Title		www.pagemac.com
USB DAC AMP		
Size	Number	Revision
B		
Date:	5/28/2015	Sheet of
File:	C:\azure dev\UDA.SchDoc	Drawn By:

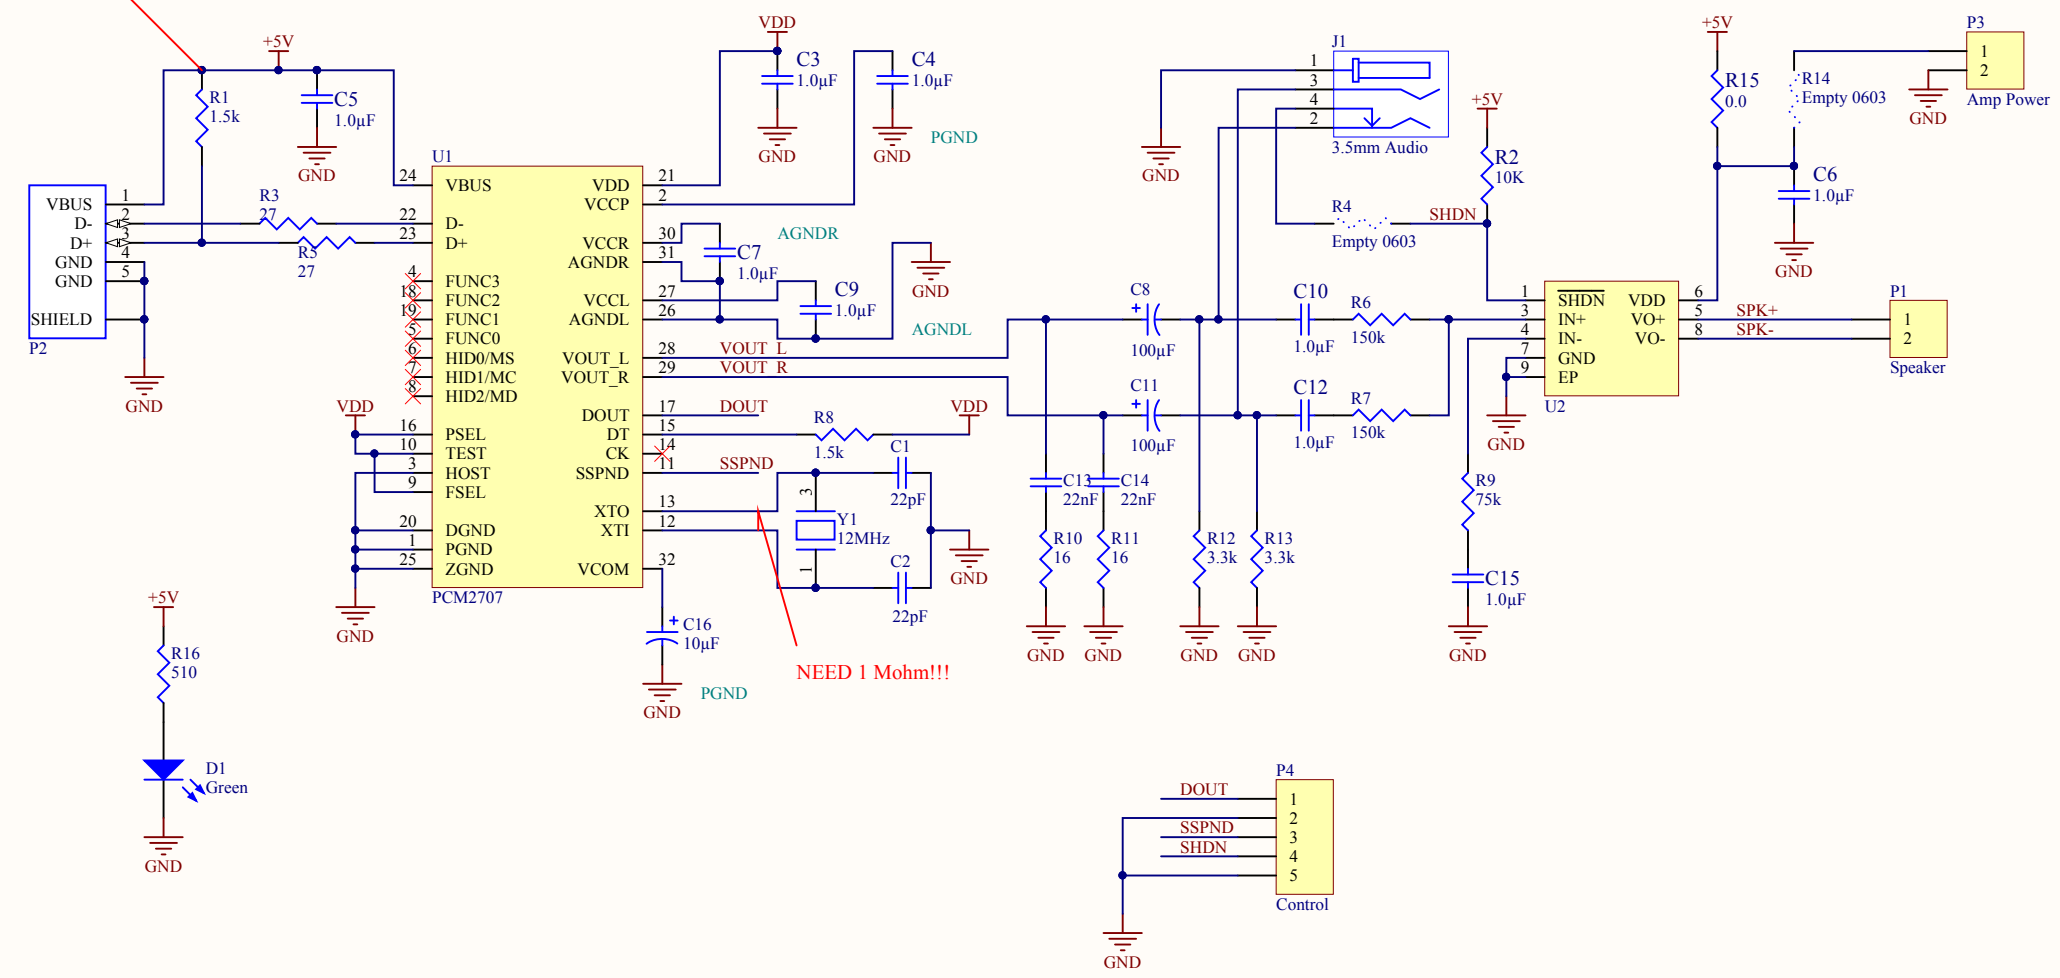
R1 should be connected to VDD, not +5V  
(but this appears to work)

NEED 1 Mohm!!!
